Heavy Duty Tow Point 150 series Prado

Modified to Suit for TJM T13 Outback Bar

RP-PRA150

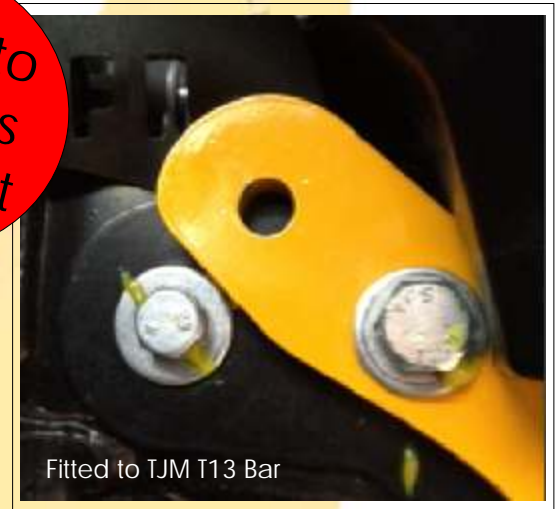
Due to customer fitment issues, we have modified the RP-PRA150 to suit for the TJM T13 Outback Bar. Due to this modification, the new destruction testing on the revised point resulted in a lower load to be applied before deformation. Subsequently the WLL on these points has been altered to 3250kgs per point. Due to the nature of the tow point components, and the way in which they could be used by untrained enthusiasts - safety is our highest priority. Setting a destruction tested WLL is a major part of encouraging safe use of these components within tested straight line pull load limits.

Rated to
3250kgs
per Point
